Technical Memorandum – Victoria Cross ISD, SSSA Traffic and Green Travel Plan – ADDENDUM

Date:	21 May 2020
To:	Sydney Coordination Office
Cc:	Department of Planning, Industry and Environment Michael James (LendLease) Lulu Woods (Lendlease) Johanna Turnbull (LendLease) Greta King (LendLease) Stephen Canty (ArcMac)
From:	Nicole Vukic (ArcMac)
Reference Document Numbers:	SMCSWSVO-LLC-SVC-TI-REP-000001, SMCSWSVO-LLC-SVC-TI-REP-000002

Since the Detailed State Significant Development Application (SSDA) was submitted the design of the metro box area has progressed in response to consultation with SCO. This addendum provides a summary of the design changes with the basement and loading dock arrangement and additional detail on the proposed management of the facility.

Figure 1: Revised loading dock layout

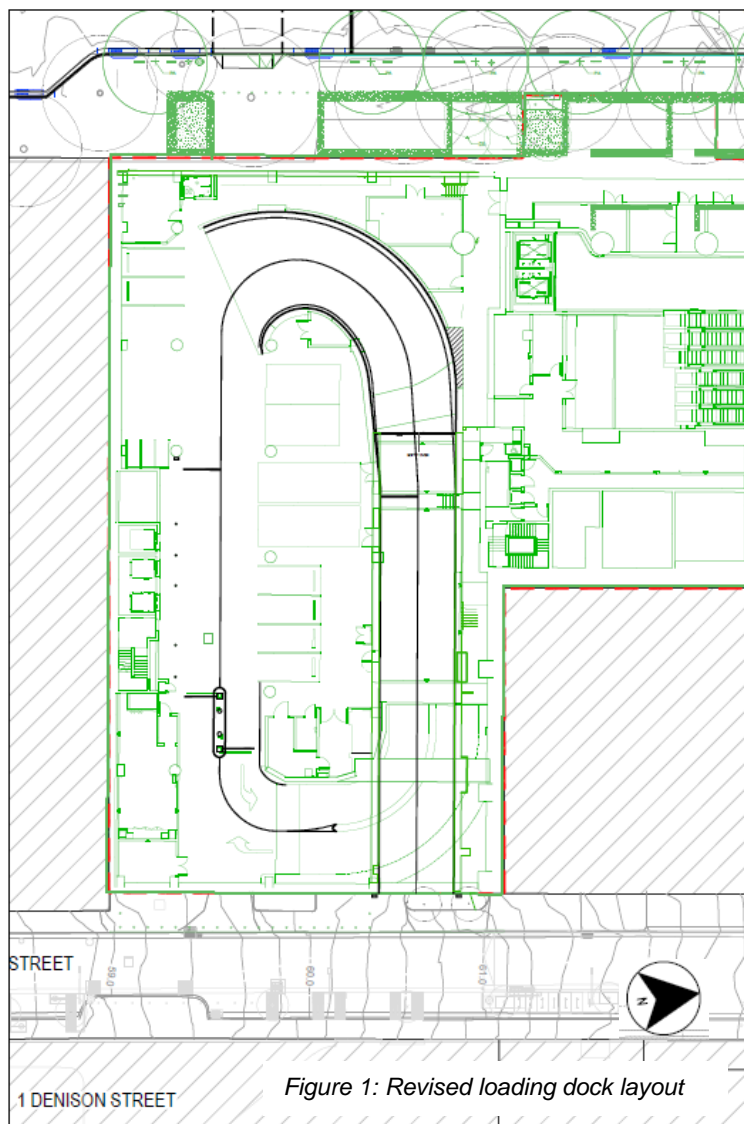
In response to concerns raised by SCO, the design has been revised since the submitted Detailed SSDA. This revised provision includes the addition of three motorbike/ bicycle courier bays located adjacent to the lift core and two light vehicle courier spaces in the south western corner of Basement Level 1 (refer to Figure 1).

The design provides a total of 13 loading bays, comprising the following breakdown:

- Two MRV bays
- Two SRV bays
- Four courier bays
- Two Sydney Metro bays
- Three motorbike/ bicycle courier bays.
